Ship's Name

Hulda Thorden

Memorandum of alterations reported since ship was surveyed for assignment of Load Lines
in April 1932.

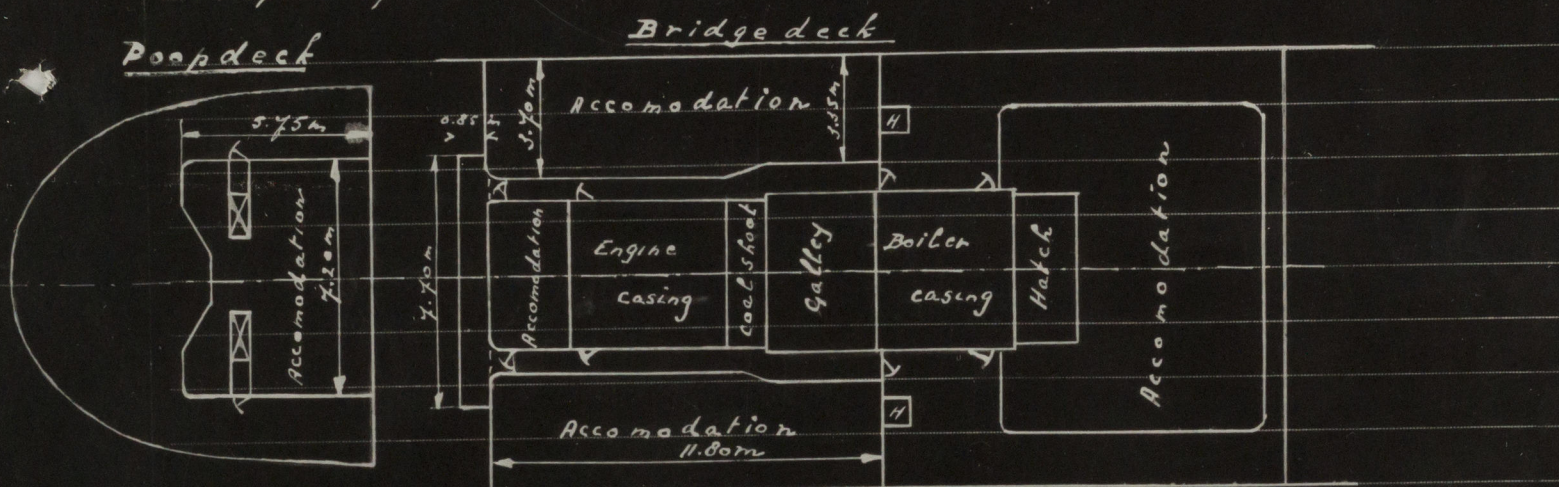
Companion way on fore castle deck removed, opening closed up. ✓
Fore castle bulkhead renewed, new opening fitted in the centre,
opening 1.60 x 1.10 m, hinged wood doors, operated from both sides, sill 18"

On the bridge deck a wing deck house has been placed (p.15) as
per above sketch, height 2.13 m, existing small wing deck houses
against engine casing removed. ✓

The coal bunker hatches have been altered and fitted in front of
both new deck houses. Dimensions 1.20 x 0.80 m, height 0.70 m, closing arrangements
as required. ✓

A platform has been fitted at after end of bridge, dimensions as per sketch.

On the poop deck a deckhouse has been built, dimensions as per sketch
height 2.13 m, enclosing a ladder way (p.15) Deck opening 1.40 x 0.65 m,
door opening 1.60 x 0.65 m, wood hinged doors, operated from both sides,
sill 18" ✓

Openings in poop front are closed up, no openings (except port lights)
in poop front bulkhead now.
